Technical Note

Transitioning Designs From DDR3 8Gb SDP 1CS to 8Gb DDP 1CS

Figure 2: Functional Block Diagram for 8Gb 1CS DDP (2 x 64 Meg x 8 x 8 Banks)

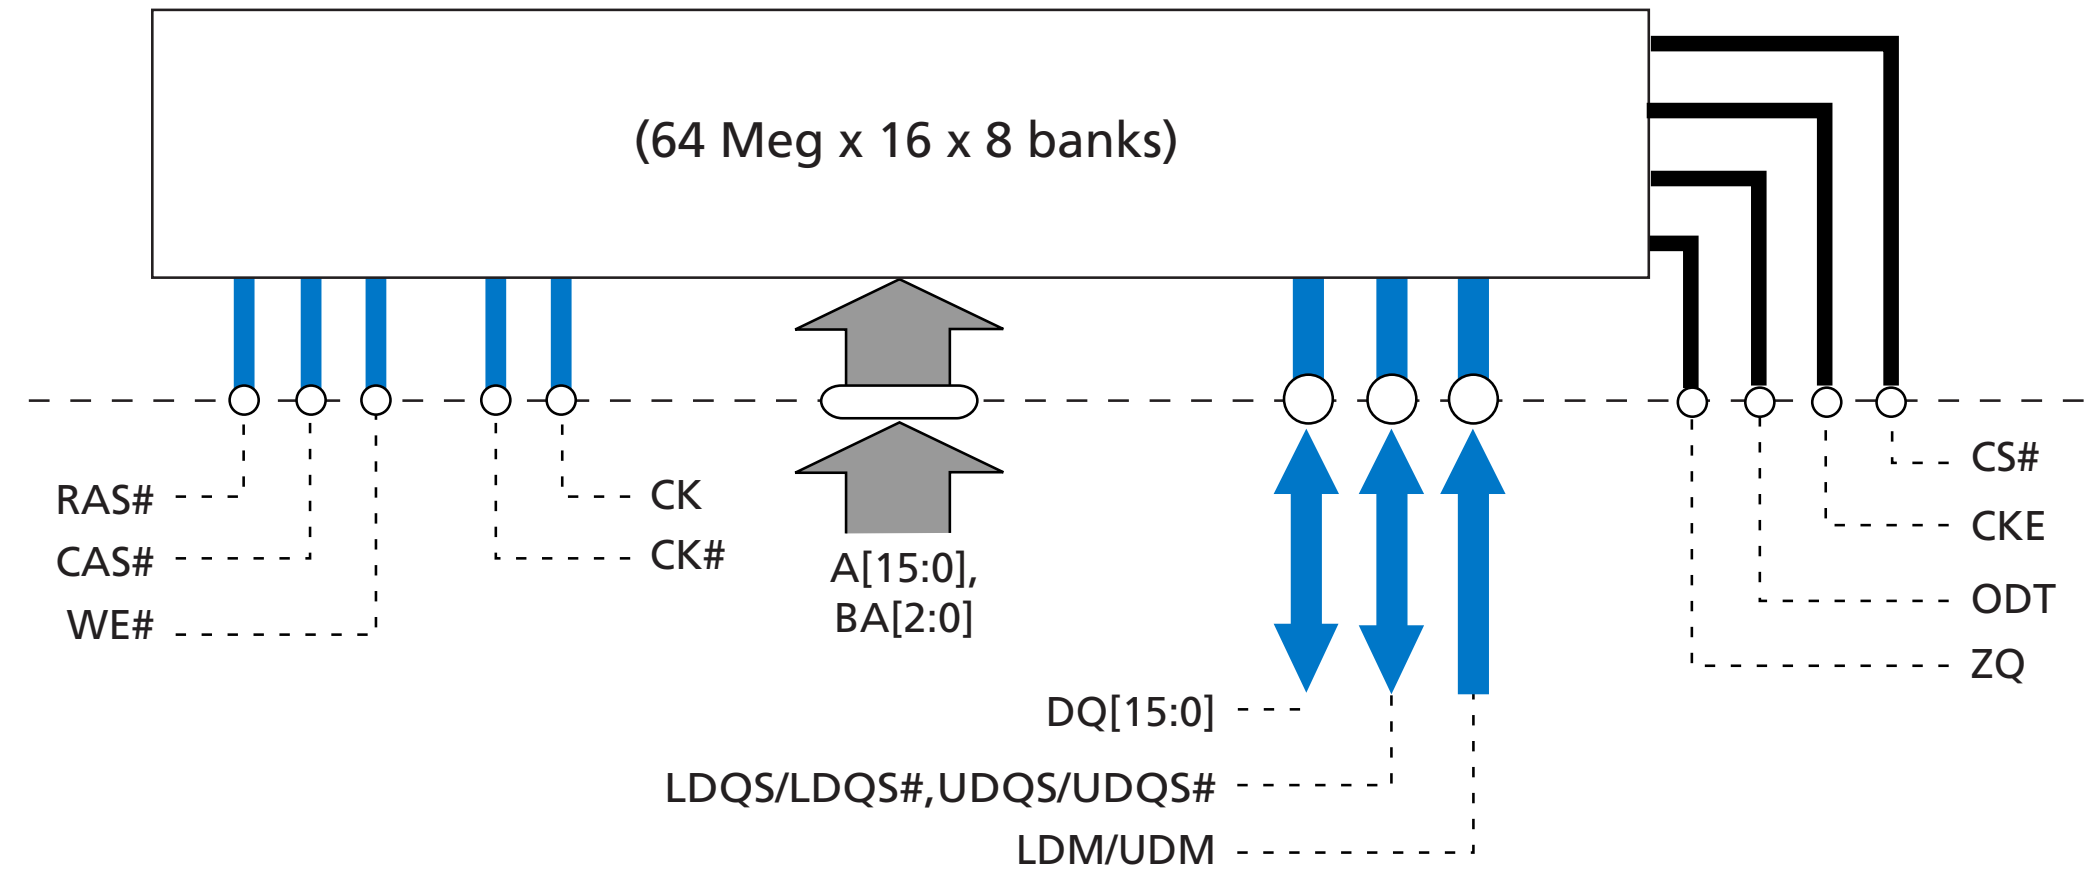
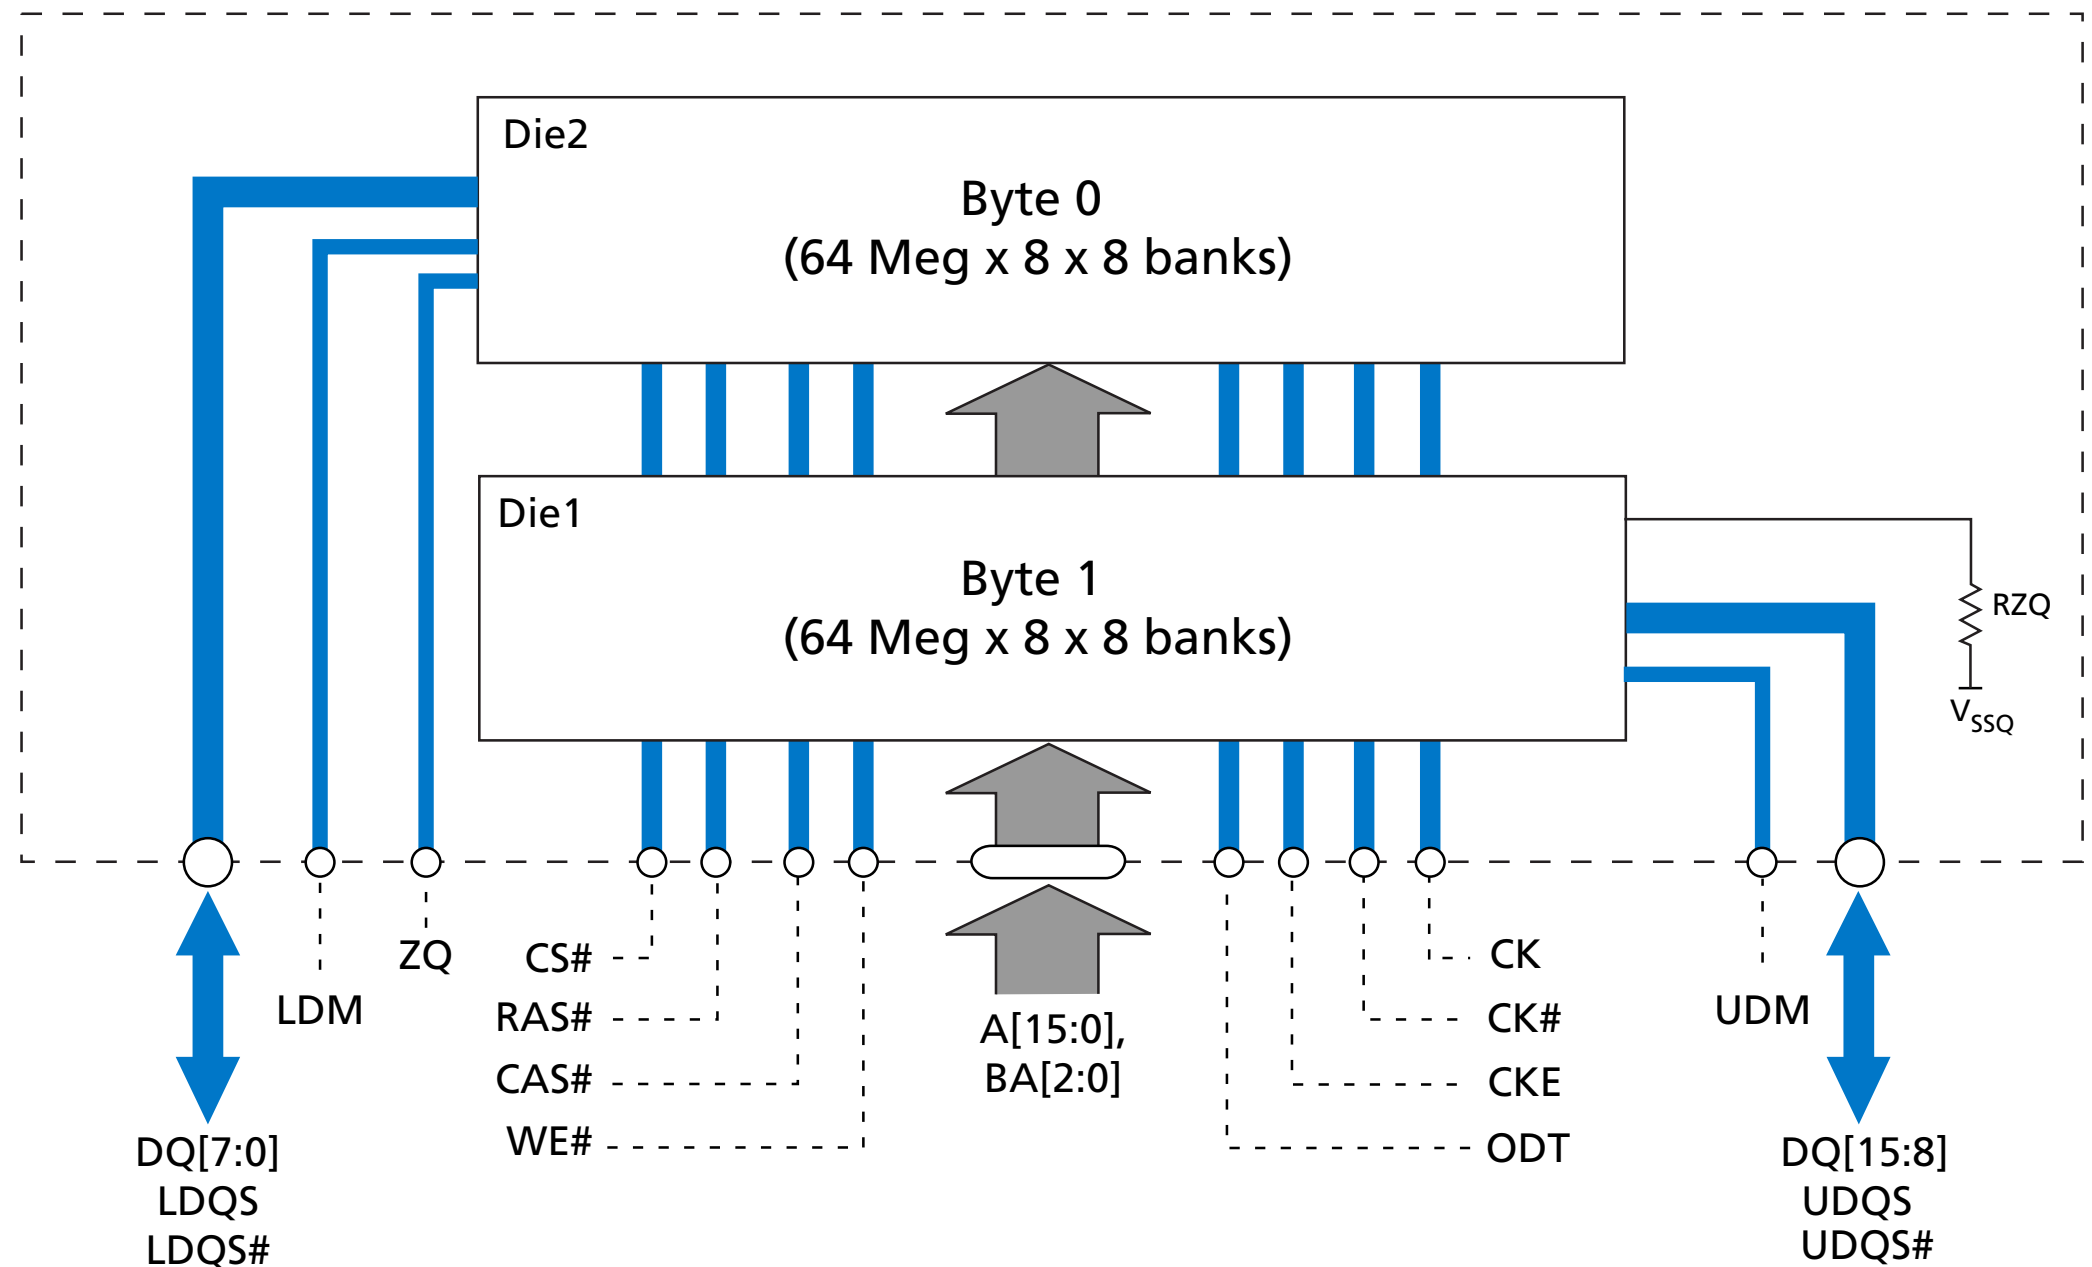
The block diagrams for the 8Gb DDR3L SDP and the DDP devices are shown in the figures below. Note that the DDP package has one internal RZQ resister and one ZQ pin out. External ballouts for both the SDP and DDP packages are the same.

Figure 4: 8Gb DDP 96-Ball FBGA – x16 (VRN, VRP)

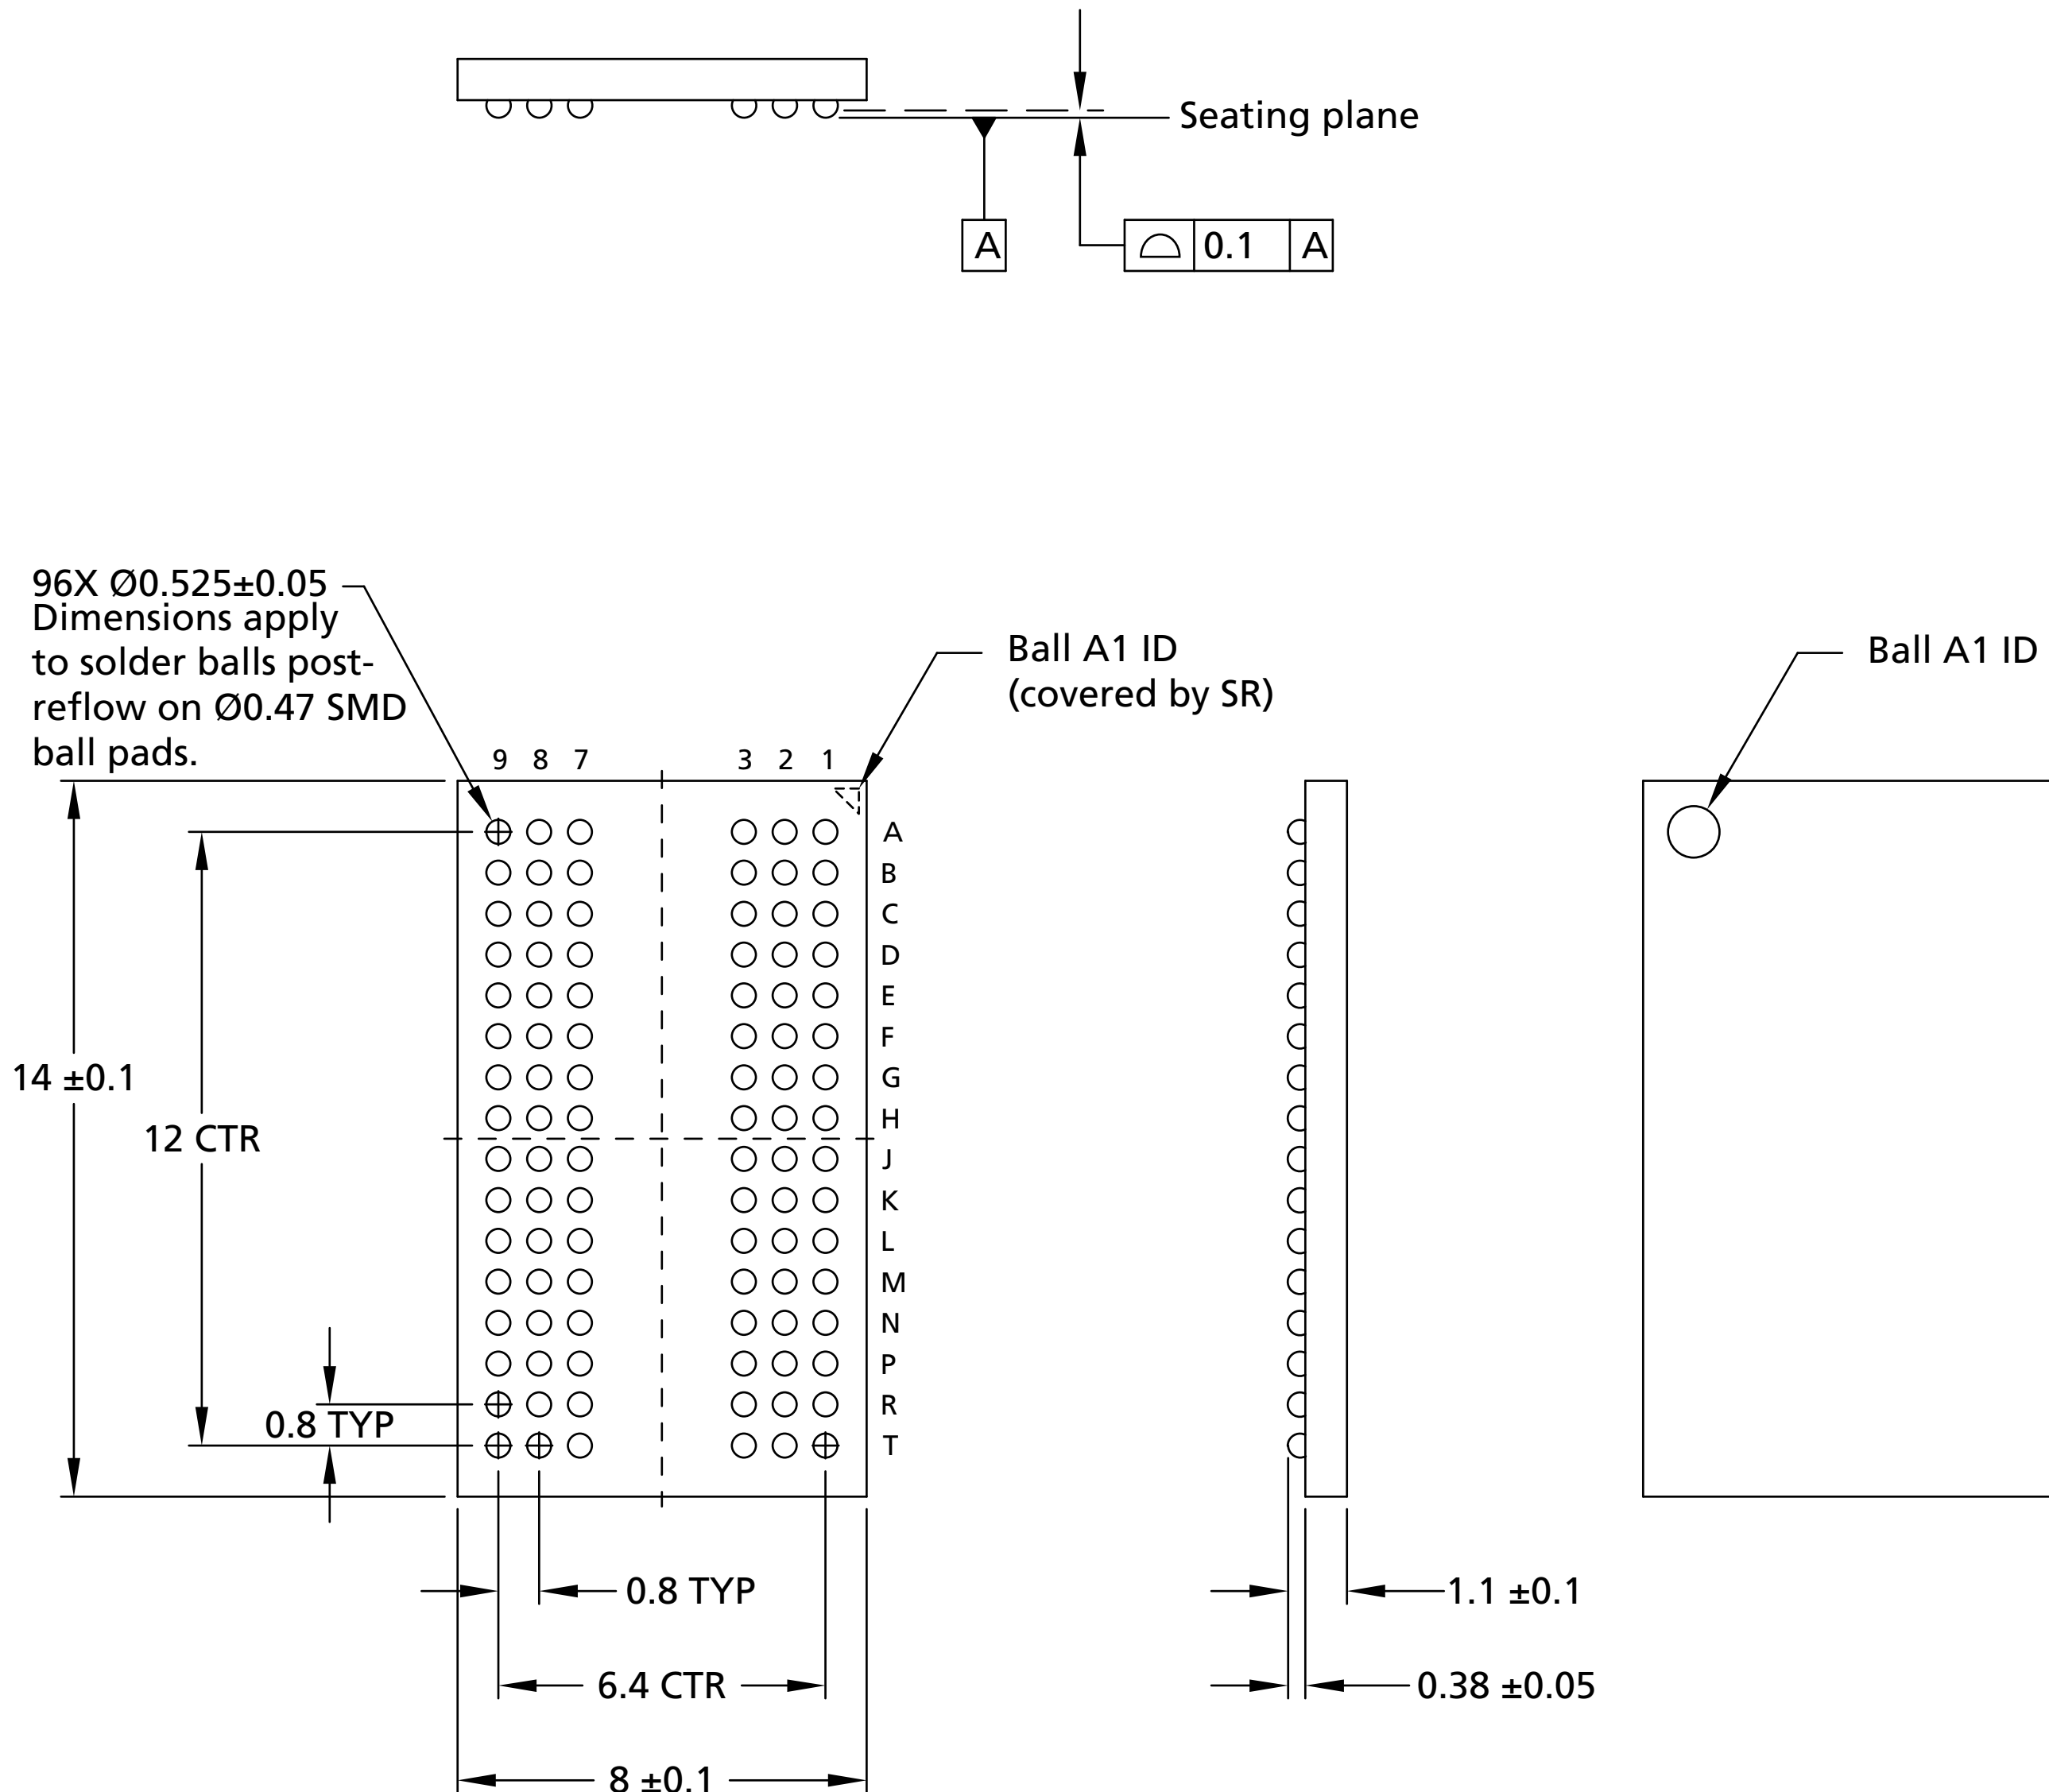
The package dimensions for the 8Gb DDR3L SDP and DDP devices are showed in the following figures, and the differences are summarized in the following table. The ball size increase for the DDP device is required to meet automotive solder join reliability (SJR) requirements. See Micron's customer service note CSN-33, a general BGA manufacturer's user guide, for information on how to easily integrate both leading-edge and legacy Micron ball grid array (BGA) packages into your manufacturing processes.

Package Code	Package (unit mm)	
	HA (SDP)	VRN (DDP) and VRP (DDP)
Dimension	9 x 14	8 x 14
Thickness (with ball)	1.1 ±0.1	1.1 ±0.1
Solder ball	96 x Ø0.47	96 x Ø0.525 ±0.05
SMD ball pad	Ø0.42	Ø0.47
Ball height	0.29 MIN	0.381 ±0.05
